TEXAS COMMISSION ON ENVIRONMENTAL QUALITY

NAME OF PROJECT: Guadalupe River Club Unit 3; Located on the north side of FM 306, east of the FM 2673 and FM 306 intersection; Comal County, Texas

TYPE OF PLAN: Request for Approval of a Contributing Zone Plan (CZP); 30 Texas Administrative Code (TAC) Chapter 213 Subchapter B Edwards Aquifer
 Edwards Aquifer Protection Program ID No. 2848.00; Investigation No. 722973; Regulated Entity No. RN105670590

**COMMENT RESPONSE TO
TEXAS COMMISSION ON ENVIRONMENTAL QUALITY (TCEQ)
COMMENTS FEBRUARY 23, 2009**

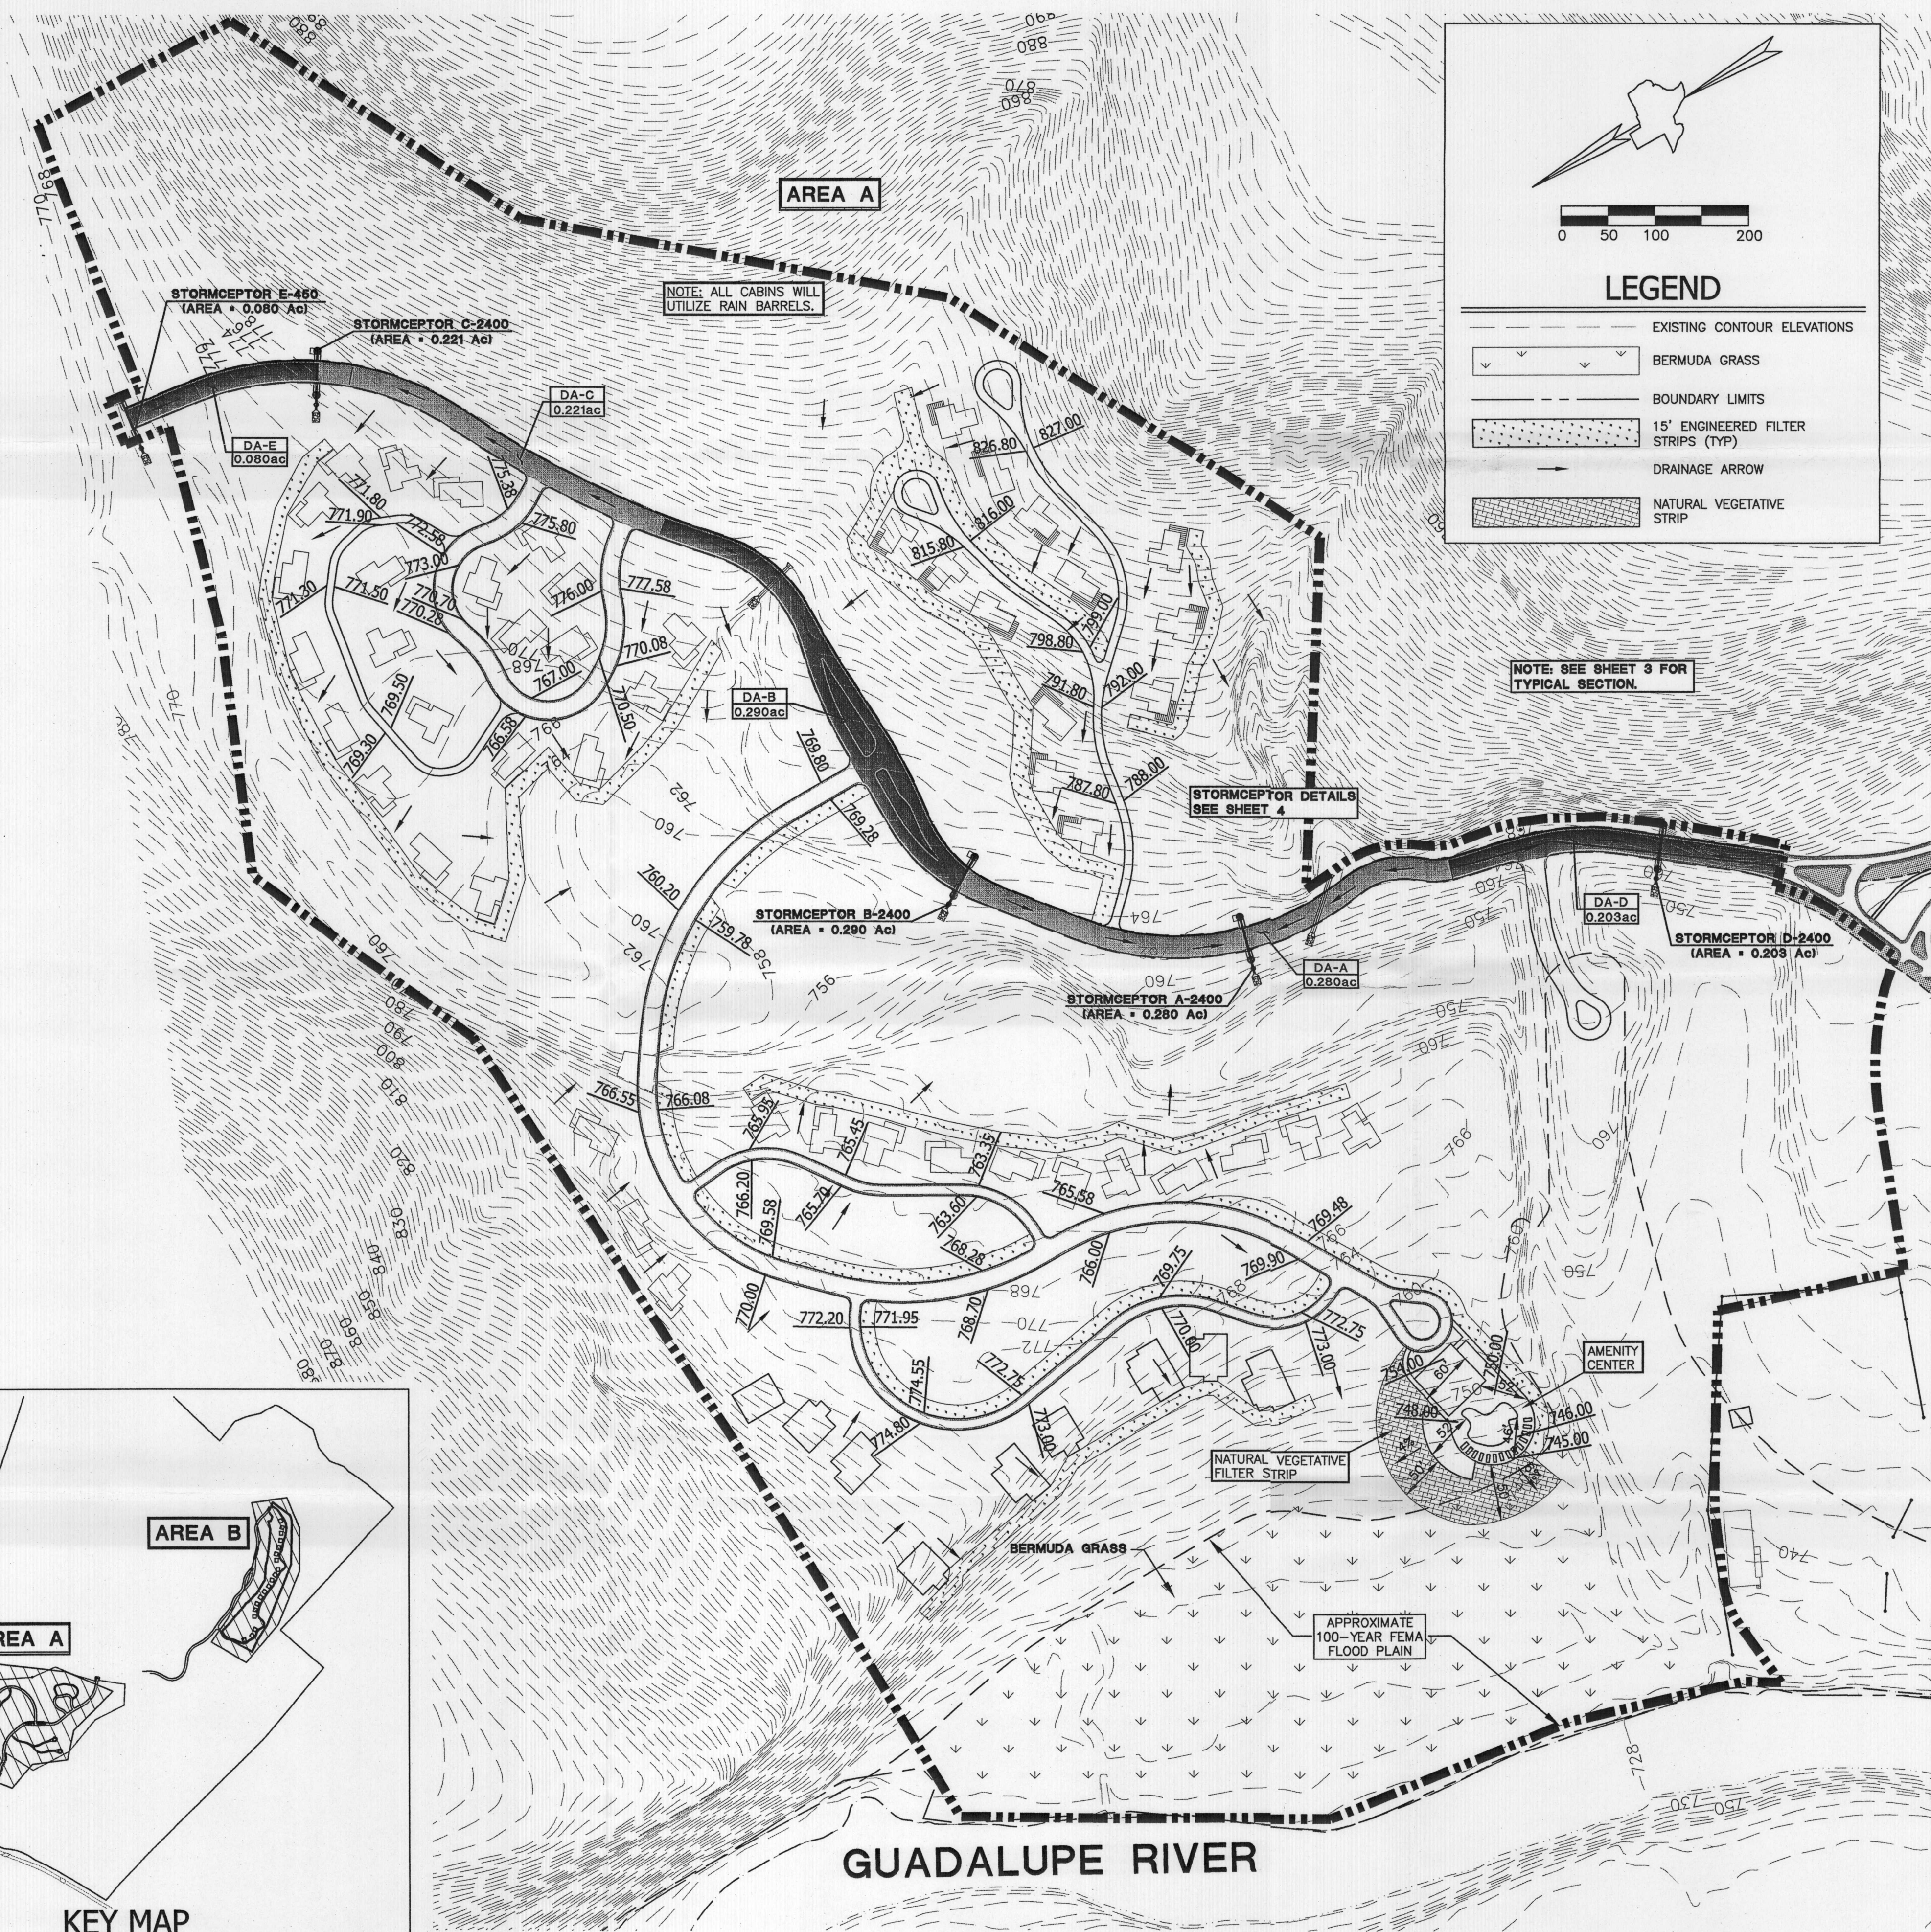
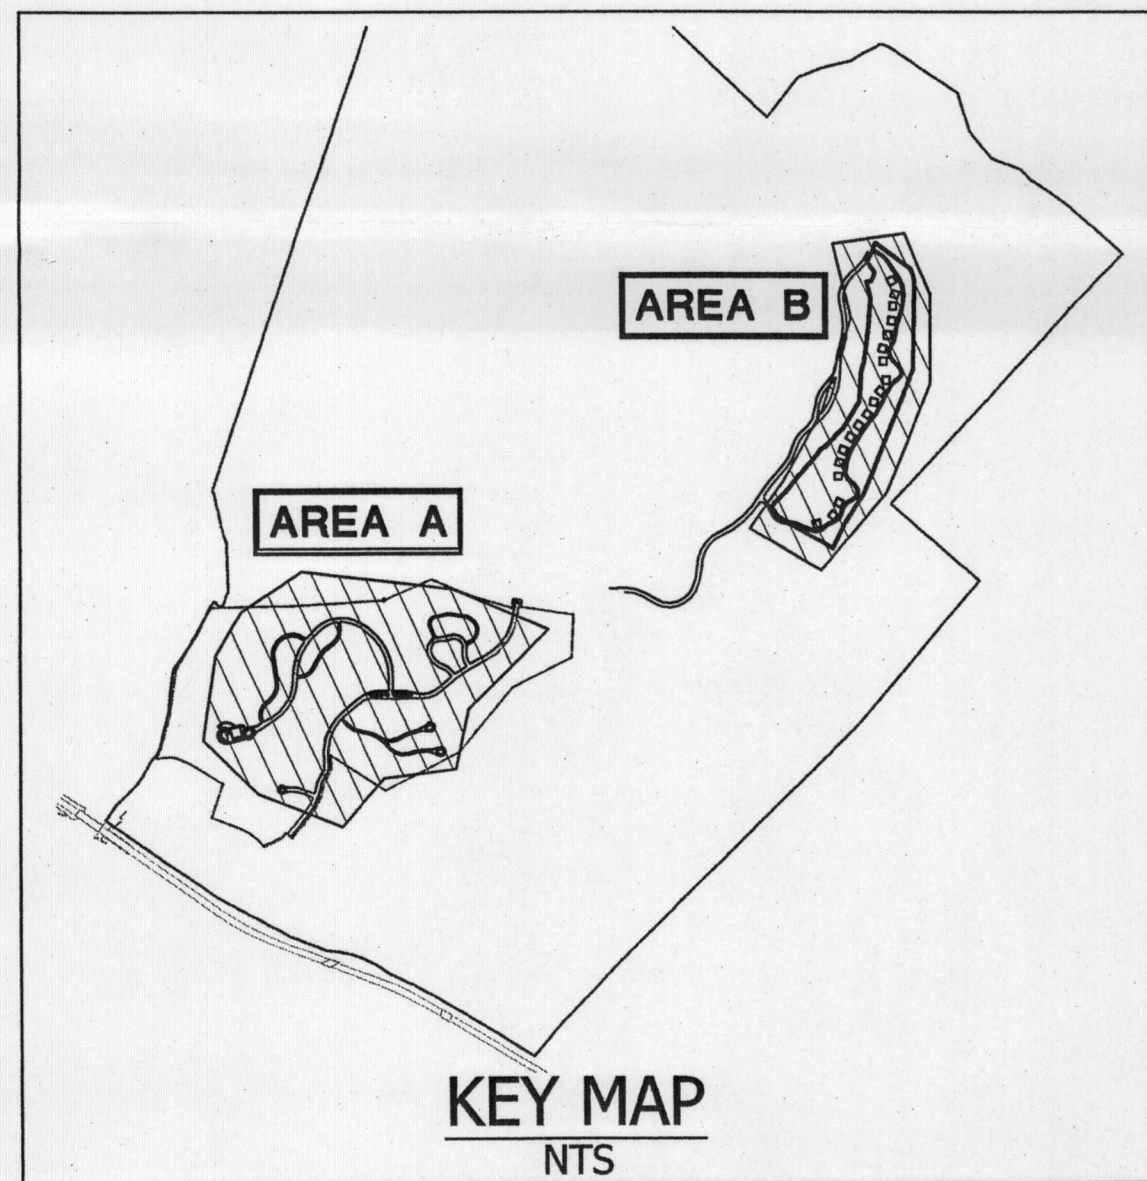
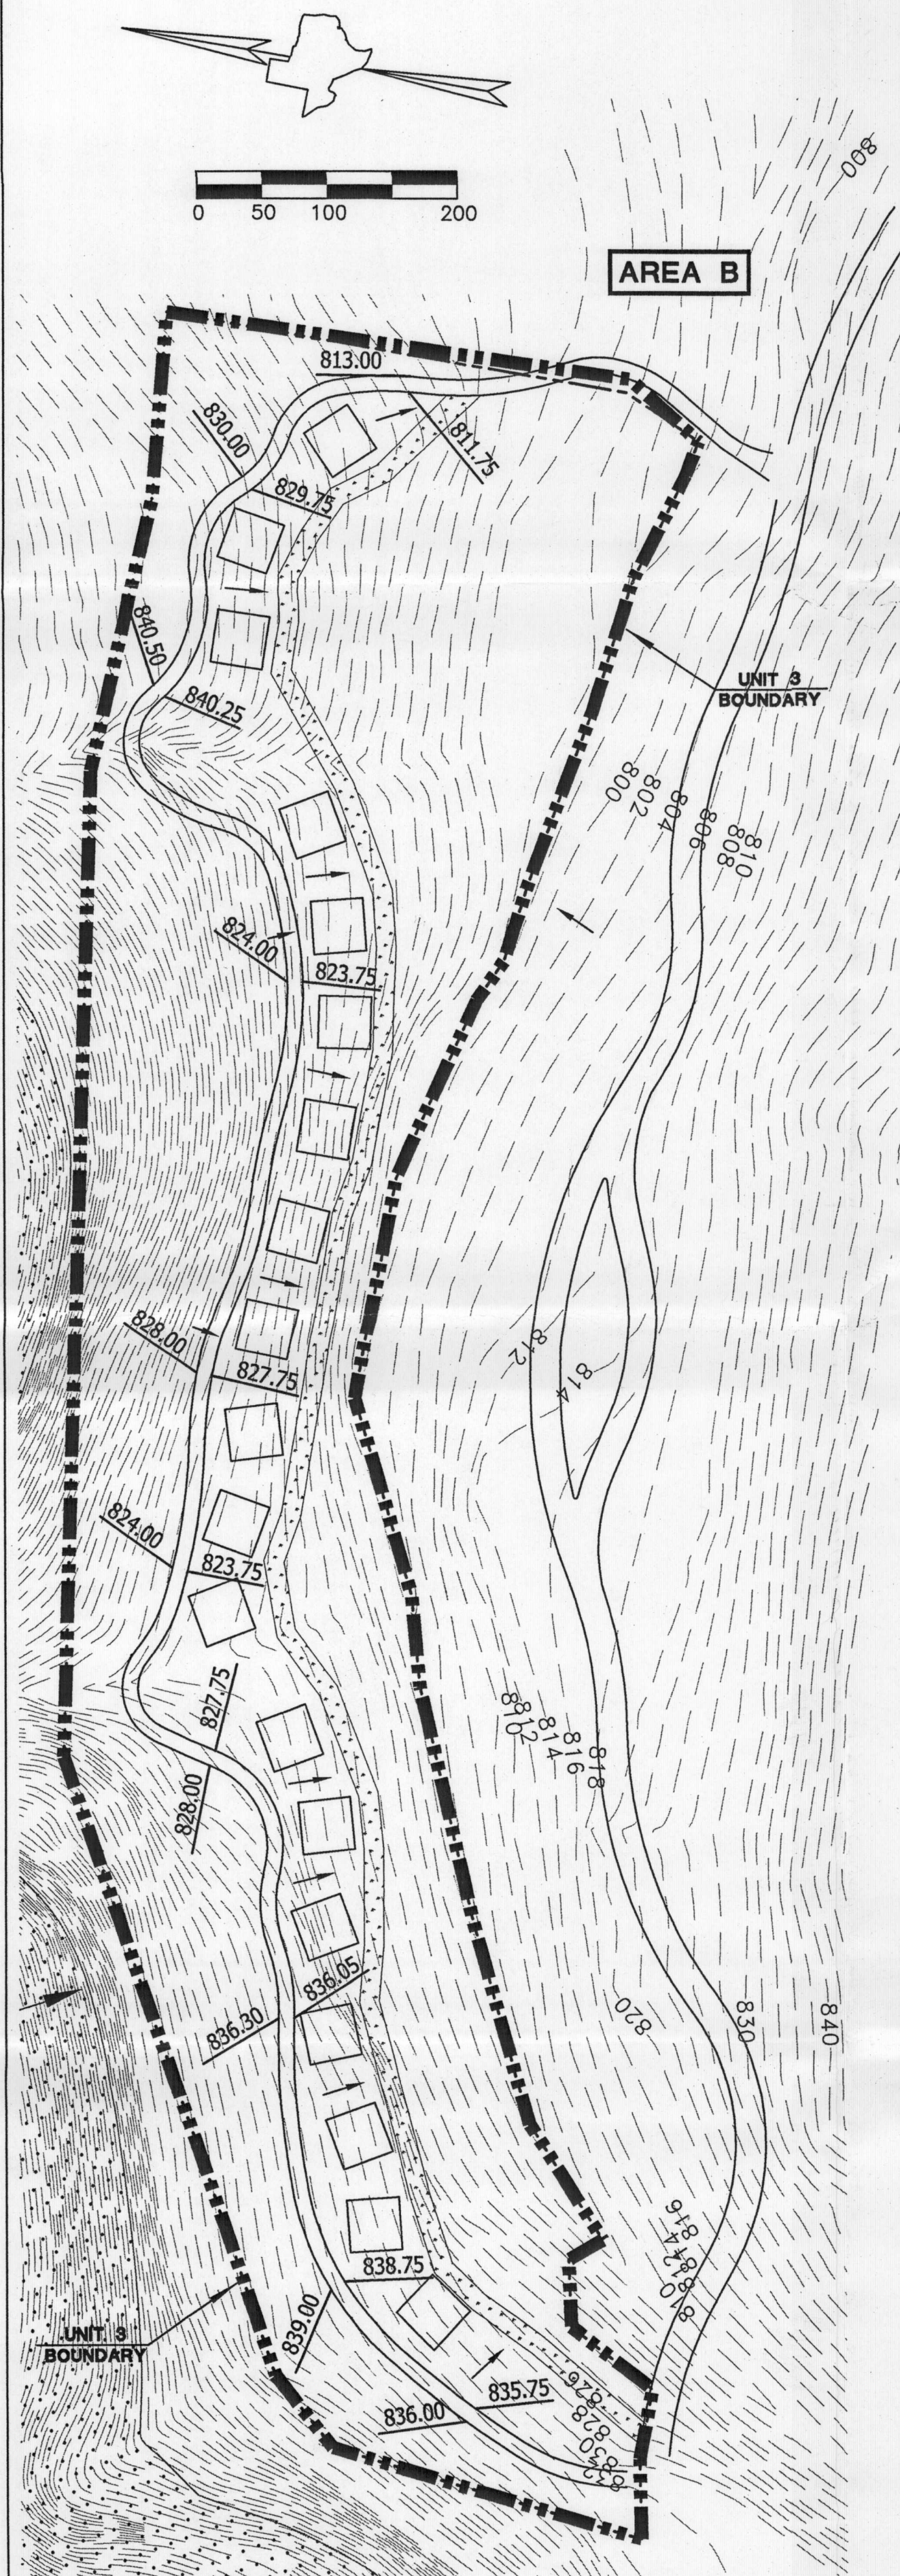
- a. There appears to be approximately 40 feet of roadway, to the north of the drainage area for Stormceptor unit C, which is not included in the drainage area. If treatment is required for this portion of roadway, revise the plan so the entire roadway receives permanent BMP treatment (or over treatment).

The Stormceptor has been relocated to the correct location of the roadway. The area has been adjusted and is updated in our calculation worksheets.

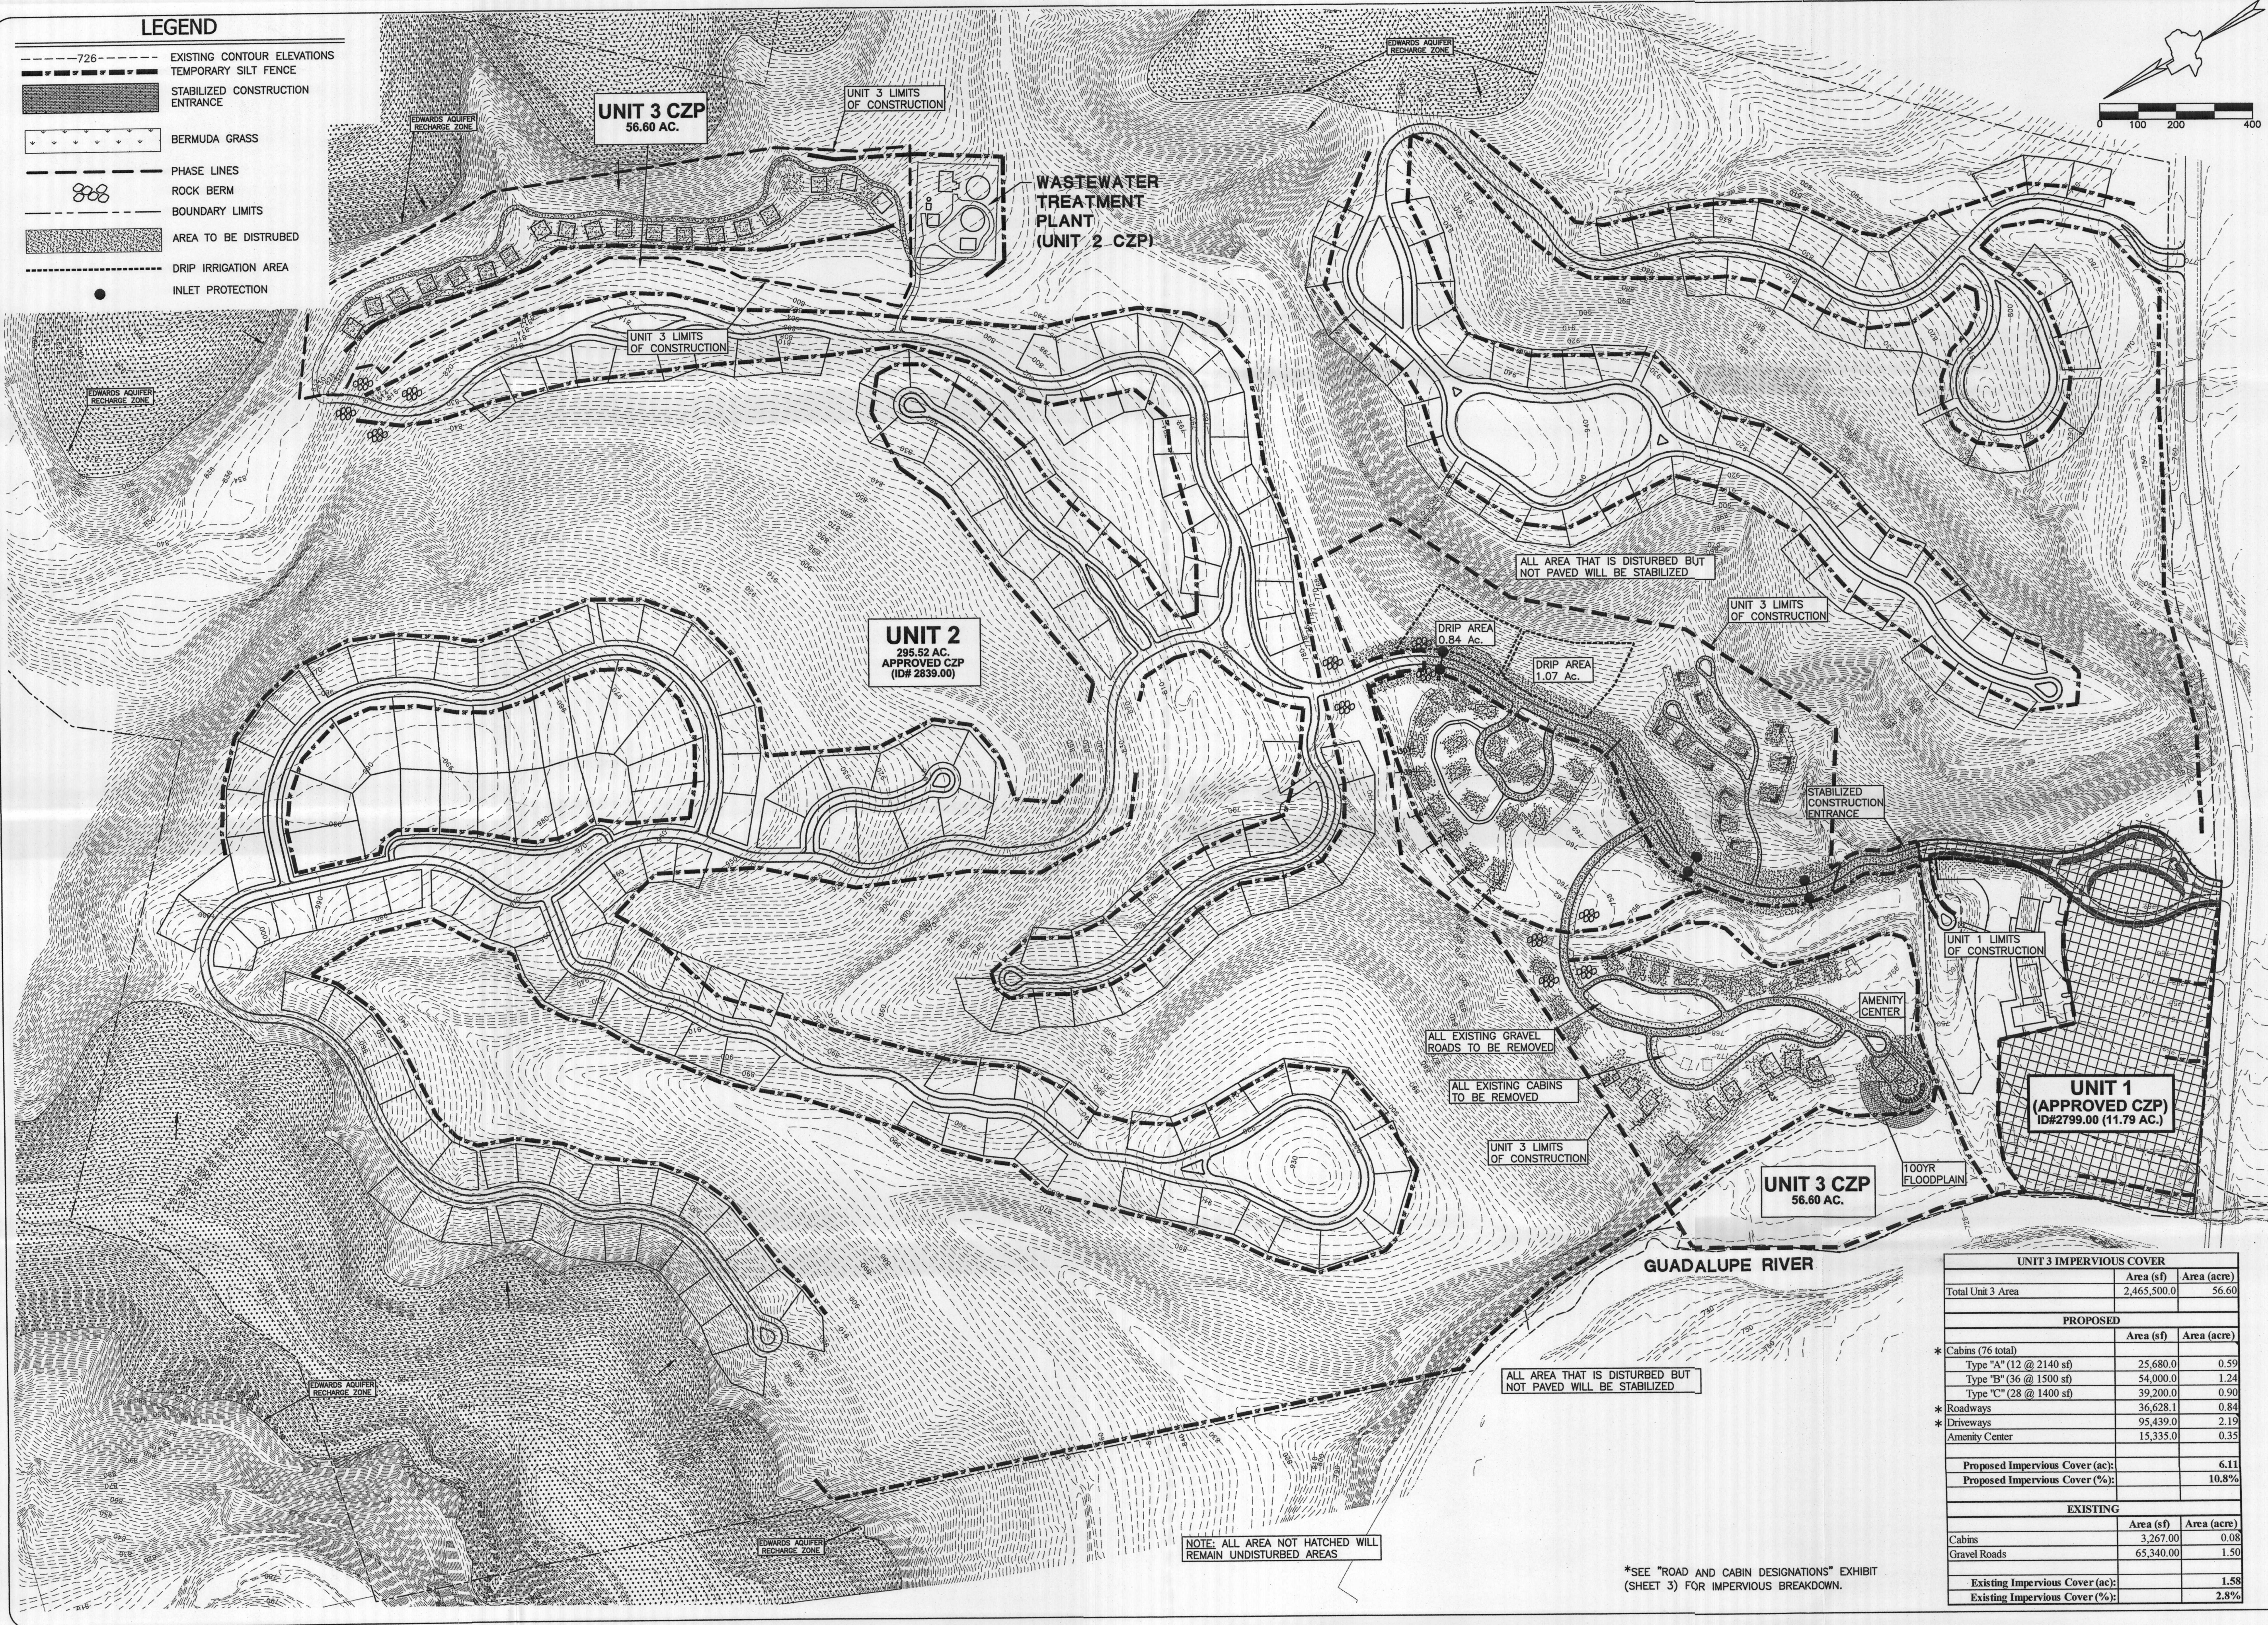
- a. The CZP Mod. 1 exhibit details a roadway in the northern corner of the site which is not detailed in the other exhibits. Please explain or revise.

This was an AutoCAD error. That road no longer exists in the site plan and will not be constructed. Both exhibits now illustrate this.
